North American Tungsten Corporation Limited

**RESPONSE TO YESAB'S ADEQUACY REVIEW REPORT
FOR THE PROPOSED MACTUNG MINE, MACMILLAN PASS, YUKON
(YESAB PROJECT NUMBER: 2008-0304)**

ADDENDUM 1 OF THE MACTUNG PROJECT PROPOSAL

July 2009

Figure 4.1.3-1

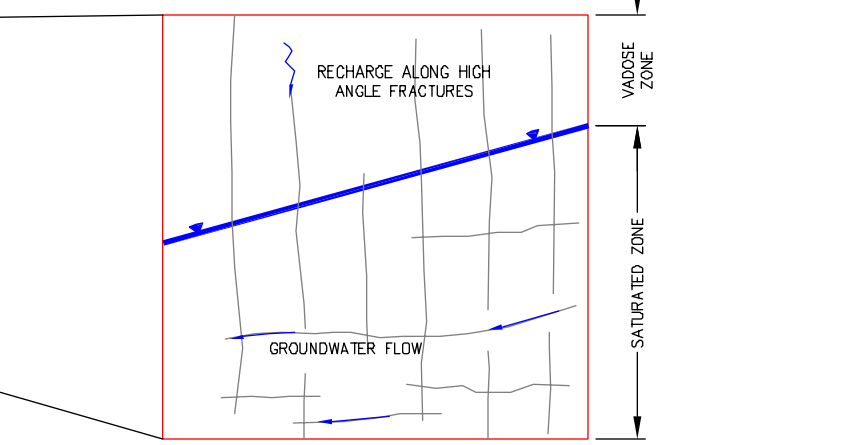
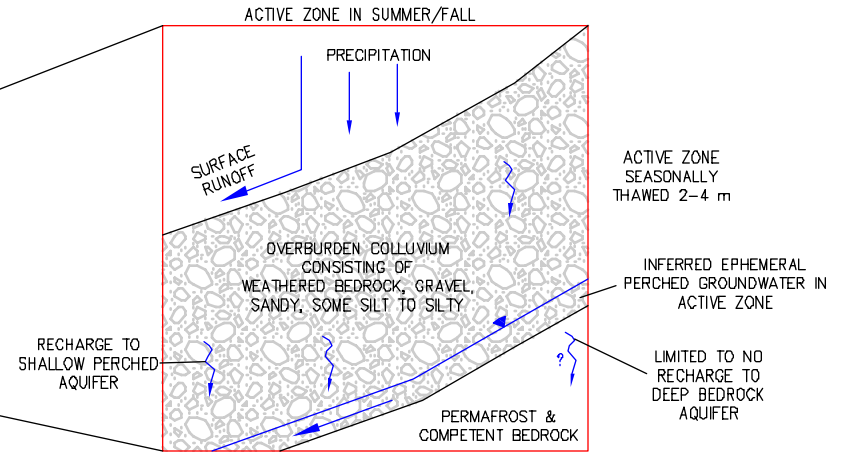
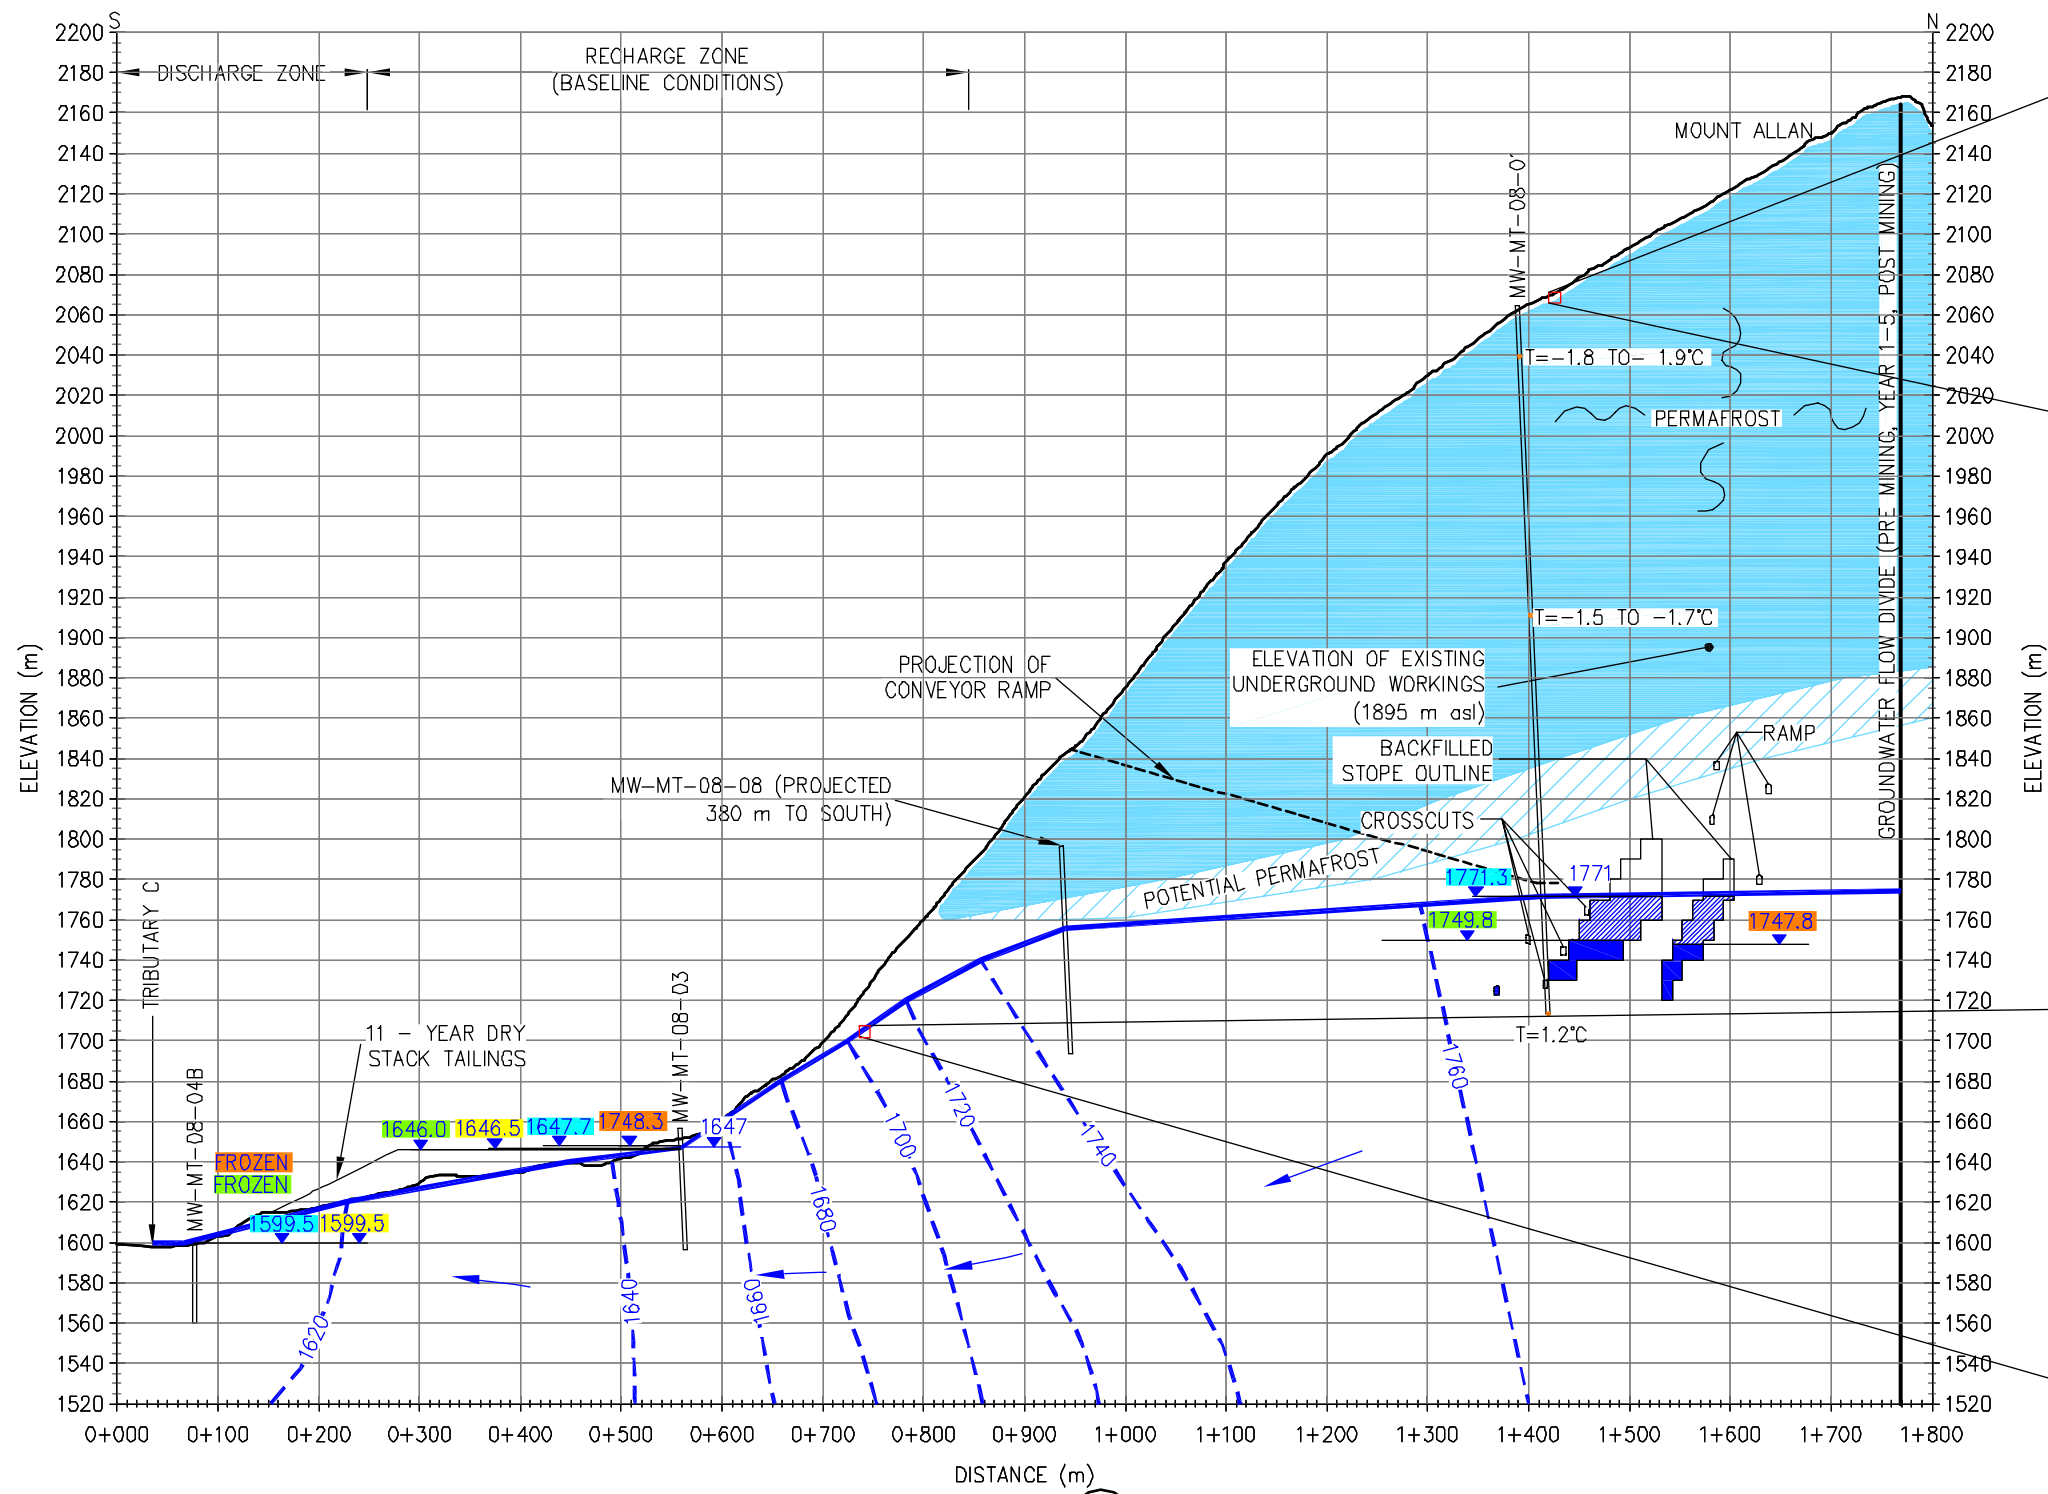
The project proposal has provided a conceptual baseline hydrogeological model to describe the pre-mine conditions. Cross sections of the model are presented in Figures 4.1.10-18 and 4.1.10-19. This model provides a general description of hydrogeology but does not provide a clear understanding of the relationship between the groundwater table, permafrost, and backfilled stopes within the underground workings. This information is important to allow the Executive Committee to consider the potential effects of backfilling potentially acid generating tailings and waste rock. Please provide the following information.

presented in the DHA and project proposal has been updated, and new cross sections have been developed. Figure 4.1.3-1 presents the locations of the cross-sections on the predicted hydraulic head map during mining operations. Figure 4.1.3-2 presents the conceptual hydrogeology for existing conditions and post closure conditions, while Figure 4.1.3-4 presents the conceptual hydrogeology during mining for Section A (north-south perpendicular to the underground workings). Figures 4.1.3-3 and 4.1.3-5 present the existing conditions, post closure and during mining conceptual hydrogeology schematics for Section B (east to west transverse through the proposed underground workings). The intent of these updated cross-sections, and the text provided below is to refine and clarify the active zone (freeze-thaw zone), permafrost, groundwater conditions, and closure backfill details in the vicinity of the proposed underground workings to address the concern expressed by YESAB and others.

Figure 5.4-1

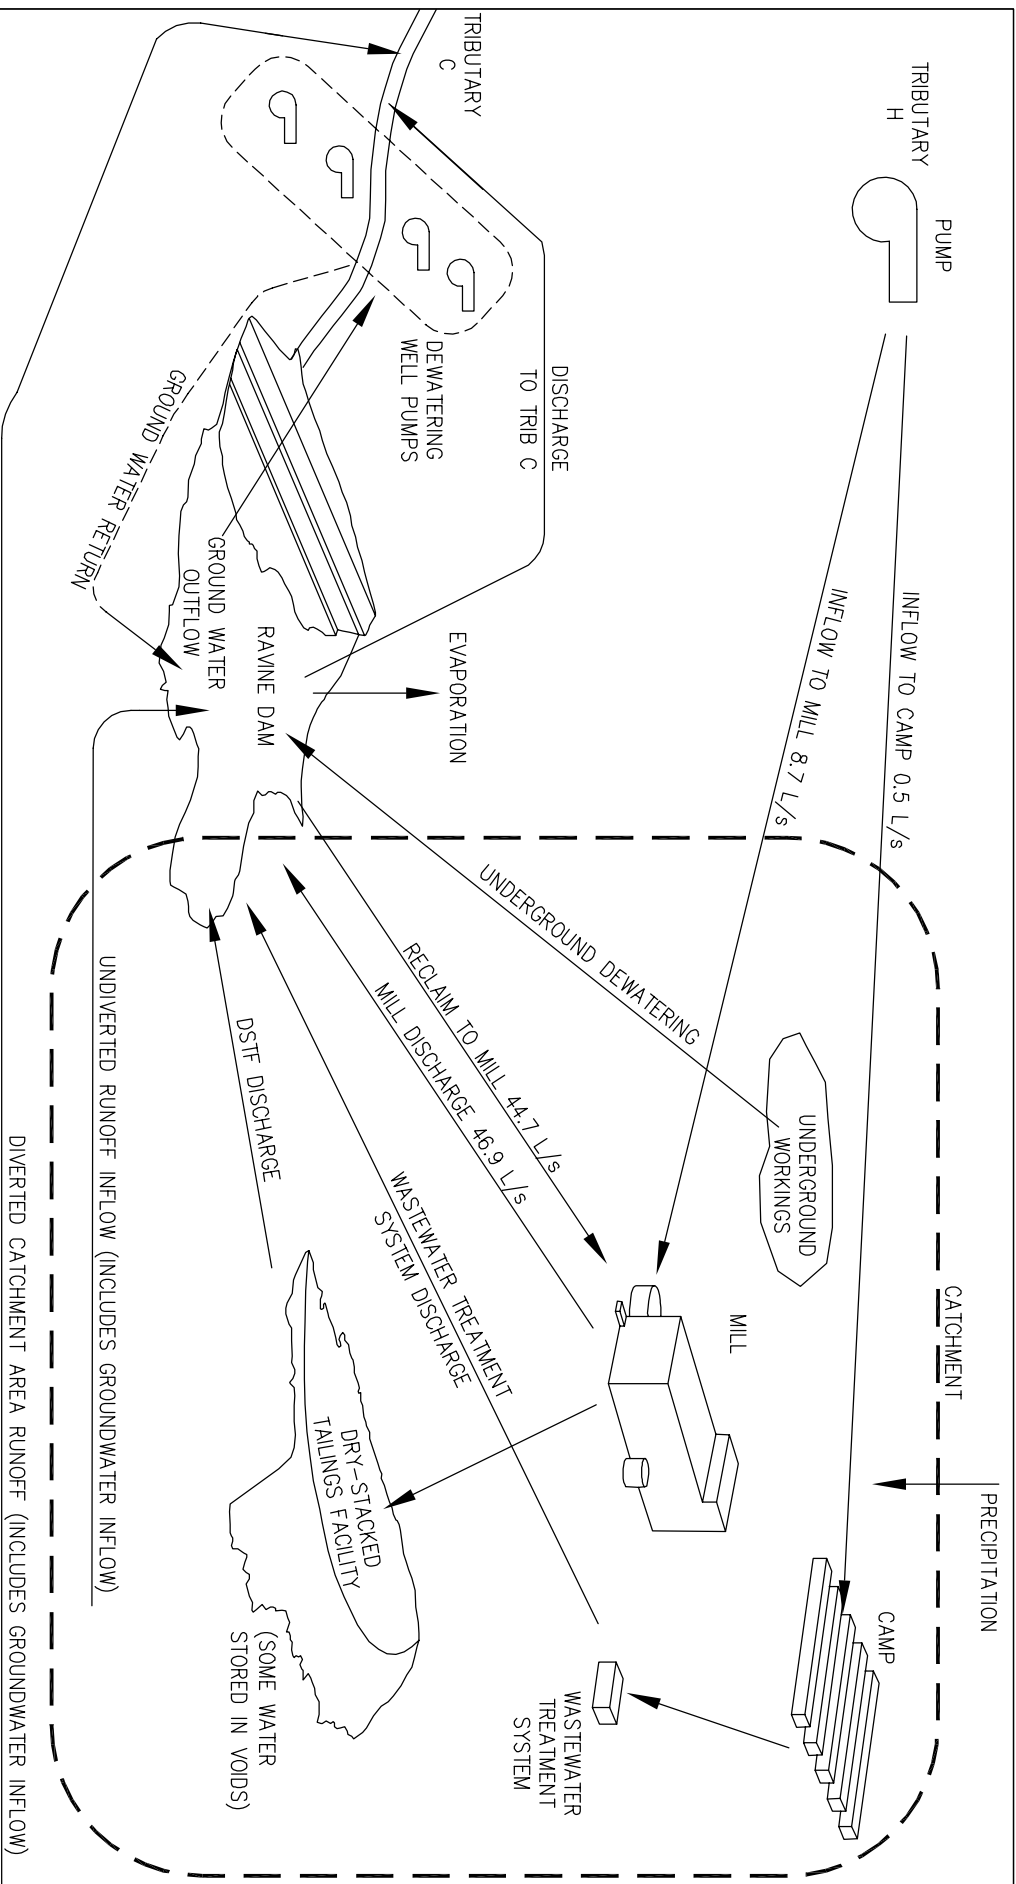
The project proposal provided information regarding site water characteristics such as baseline climate, hydrology, and hydrogeology data. Potential effects related to these values were also characterized providing some indication as to the water balance for the site. A general water balance diagram and information was provided for the ravine dam reservoir during the operation phase (Figure 5.4.3-9 and Tables 5.4.3-4 and 6.2.8-2). However, some information in the project proposal complicates the understanding of the water balance at the mine site. For example, the project proposal indicates that seepage volumes from the DSTF are estimated to be $74\,000 \text{ m}^3/\text{year}$ (pages 427 and 541) while Tables 5.4.3-4 and 6.2.8-2 indicate that DSTF seepage inflow into the reservoir will be approximately $9\,461 \text{ m}^3/\text{year}$.

Figure 5.4-1 contains a conceptual diagram showing the various infrastructure components that are part of the water balance. The project proposal (p.577) indicates that the groundwater pumpback wells will be located approximately 100 m downstream of the reservoir. The outfall location for discharge from the reservoir will be located downstream of the pumpback wells as is the outflow location for the discharge from the diversion channel.
